FERGUSON MALONE ARCHITECTURE

> **Re: ARB21-73 Resubmission** 2 South Astor Street AstorBuck Properties, LLC

We have revised the drawings set to properly indicate the existing conditions at the upper floor of the building. No change in configuration is being proposed to this level. Please refer to sheets A-3.00 and A-3.0. Also we have revised the site plan to include additional tree planting east of the proposed project – see sheet G-1.1.

HUDSON LOFT PARKING LOT

G-1.11

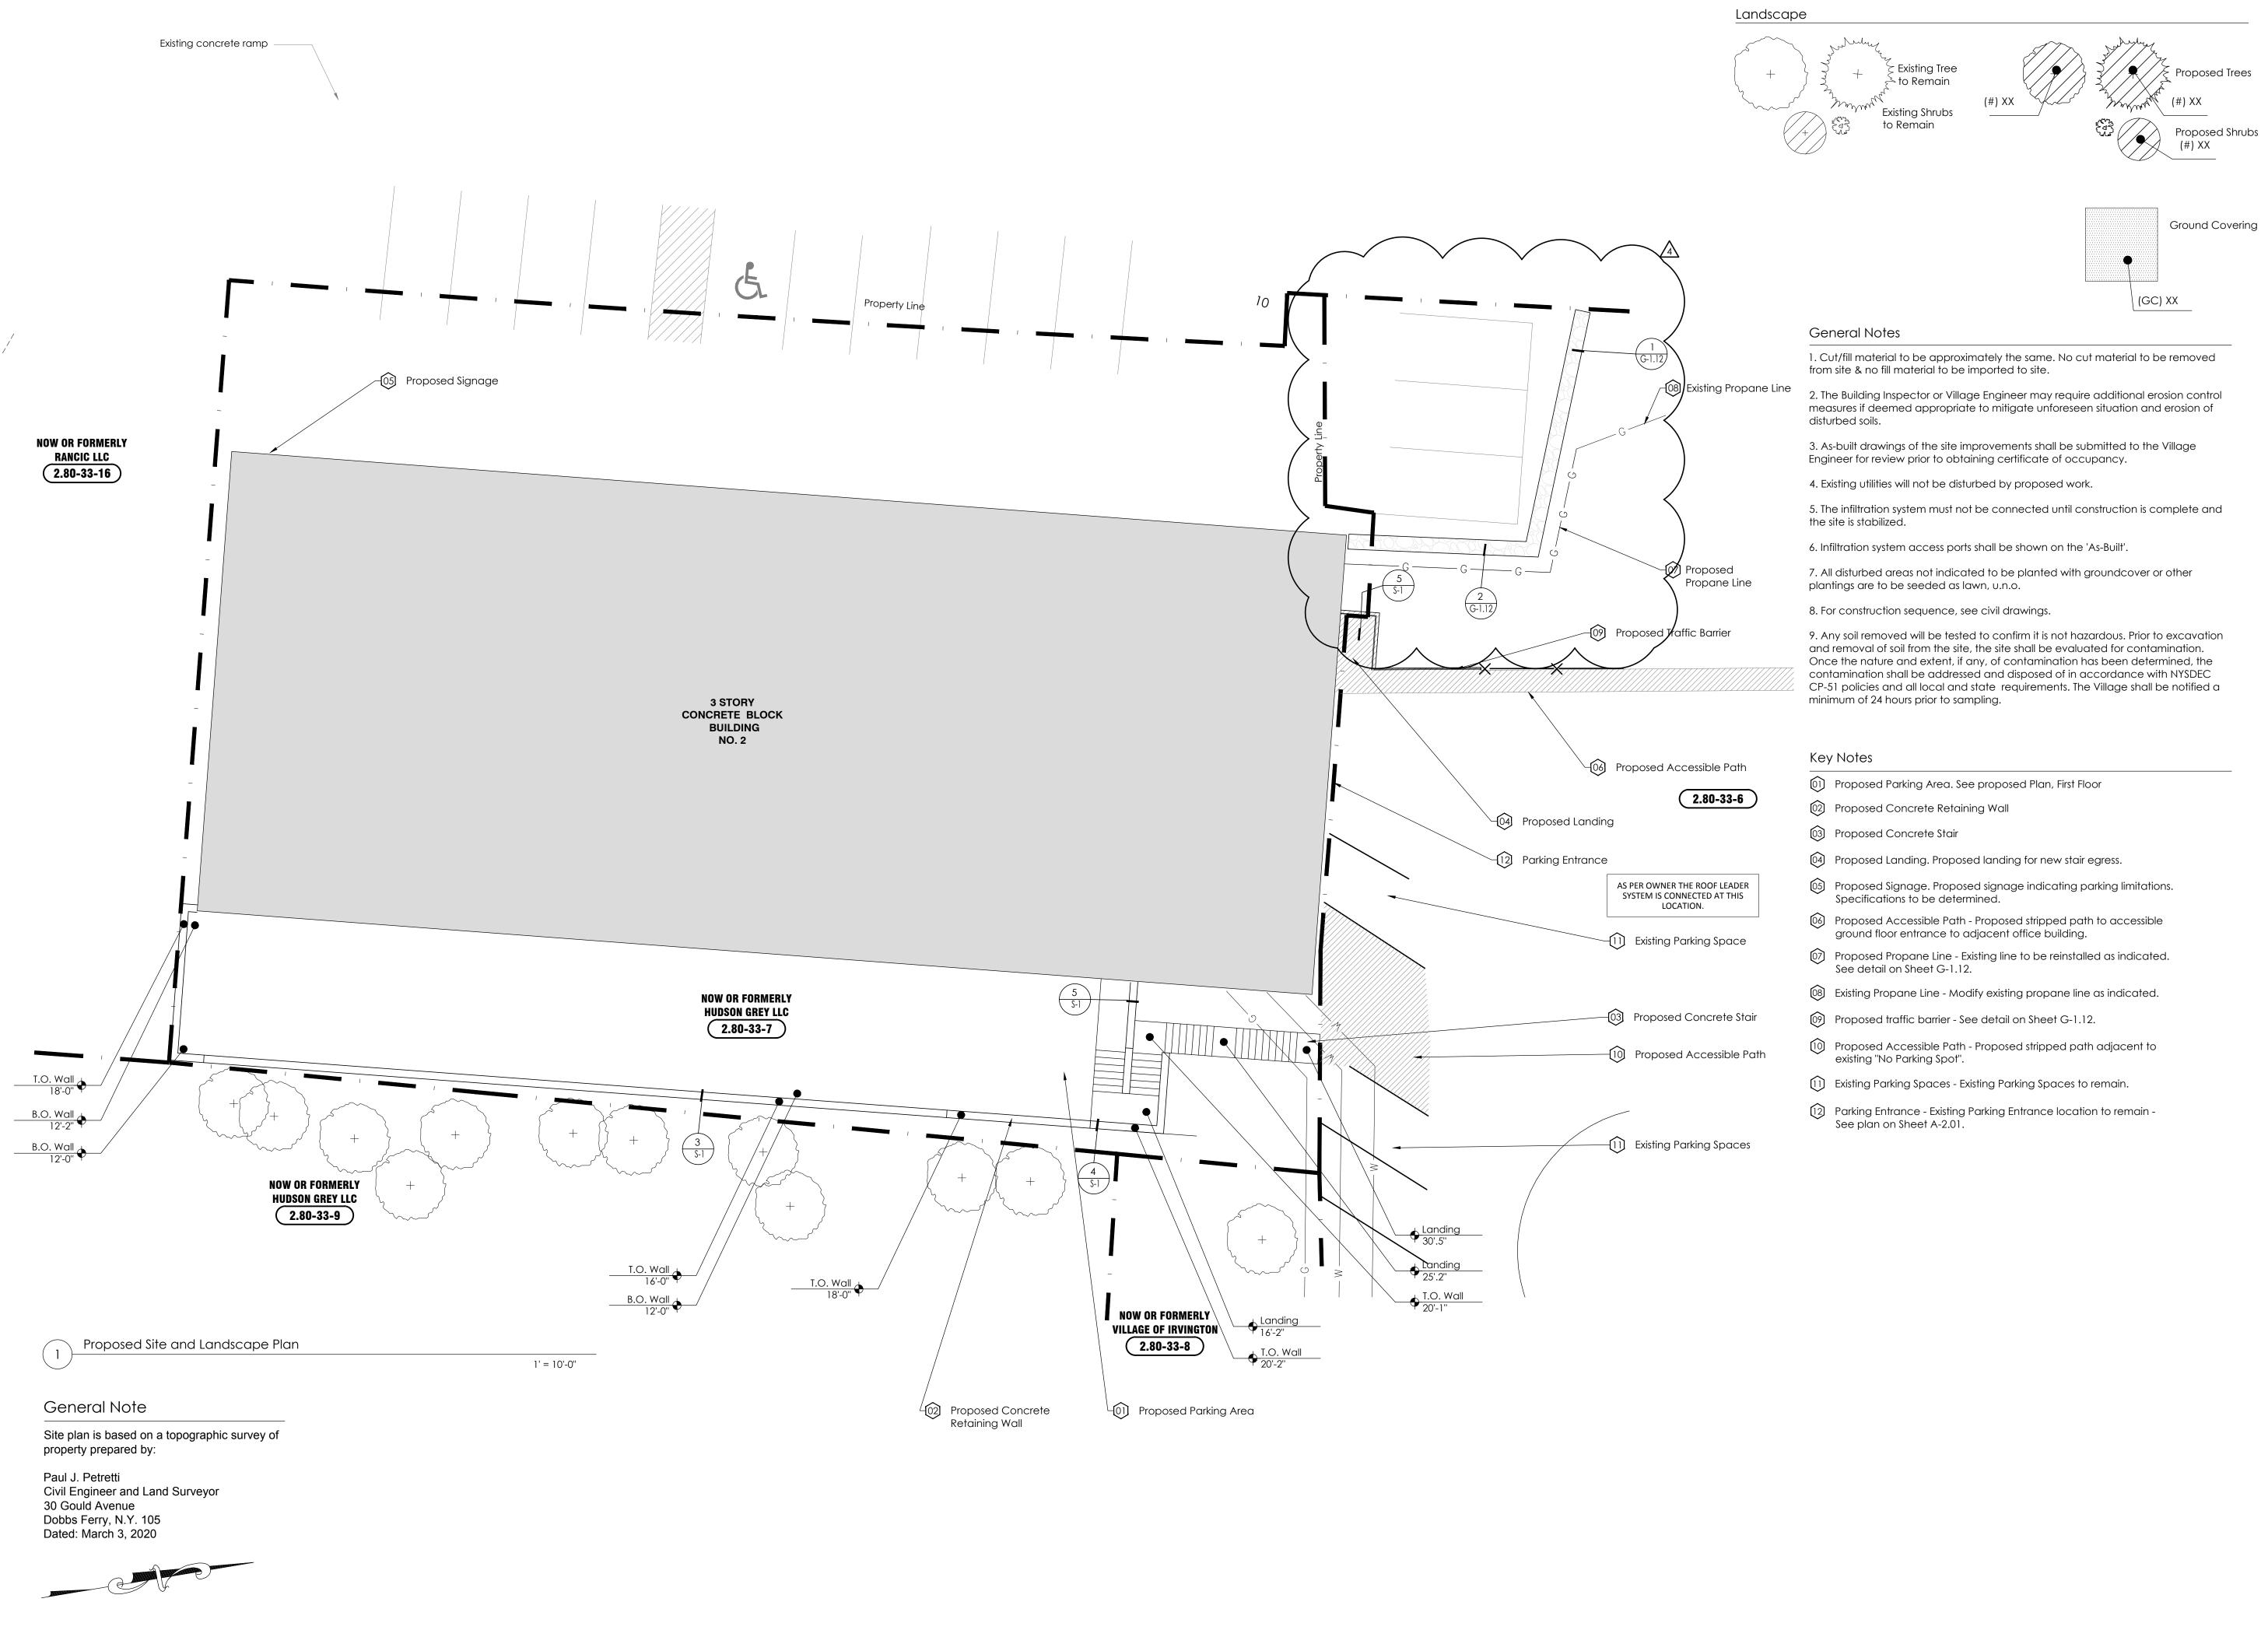
We believe that the proposed renovation will not be visible from Buckhout Street due to the existing grade and existing vegetation. As mentioned above the site plan has been revised to include tree planting to fill in any opening in the existing vegetative screening.
